Dear Wataru,

Thank you very much for your careful review, and for raising these valuable questions and suggestions. Below are my responses.

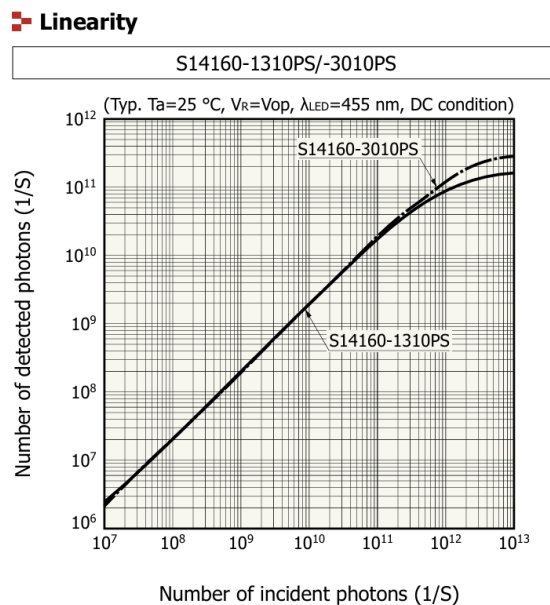
- [2.3 SiPM Response]

"This behavior is attributed to the pulse width of..."

--> It was not clear why a short pulse width was the reason for a saturation point.

Could you explain clearly ?

Sorry for the unclear description. This paragraph was polished, and more explanation was added.
